CITY COUNCIL PUBLIC HEARING

MODIFICATIONS TO THE WASTEWATER TREATMENT PLANT UPGRADE - PA 17-075

APRIL 15, 2019

MAINTENANCE WAREHOUSE

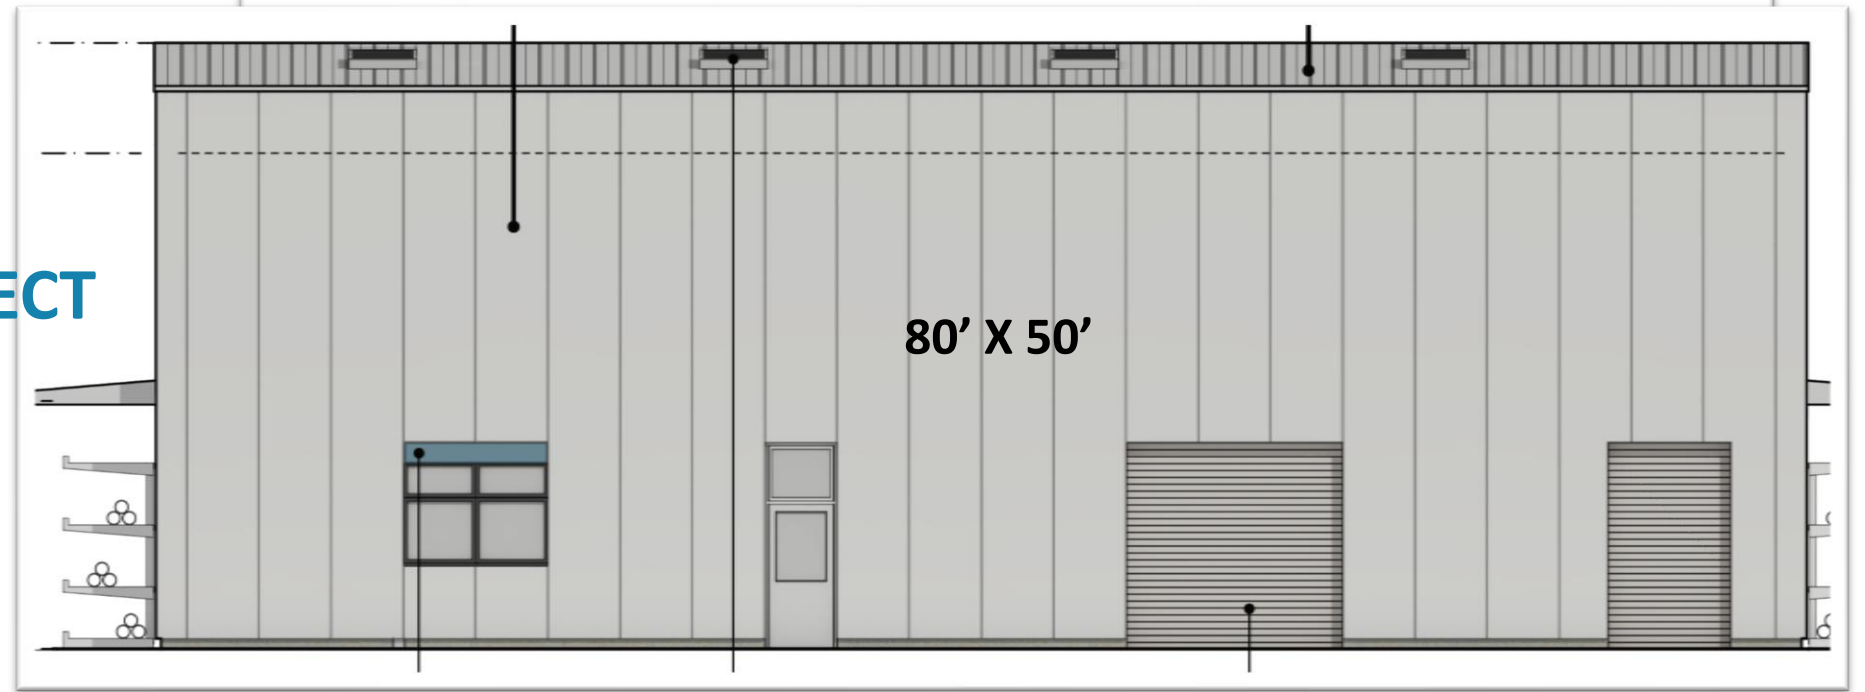
1. Replacement of circular clarifiers with rectangular and a reduction of the structure by 31,950 SF
2. Relocation of Administration Building
3. Increase in size of maintenance warehouse building by 2,800 SF and a change in the exterior materials
4. Landscape modifications

MAINTENANCE BUILDING EXTERIOR

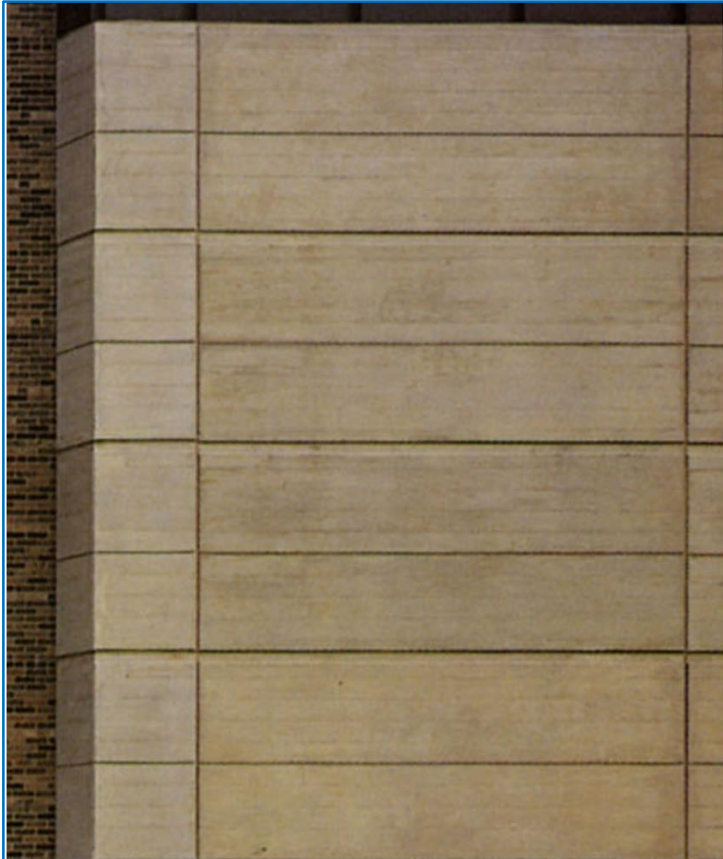
MATERIAL: POURED-IN-PLACE CONCRETE
FINISH: HORIZ. & VERT. REVEALS
COLOR: -

INSULATED METAL WALL PANEL SYSTEM

MANUFACTURER: KINGSPAN OR EQUAL
PRODUCT: SHADOWLINE
MATERIALS: DOVE GREY
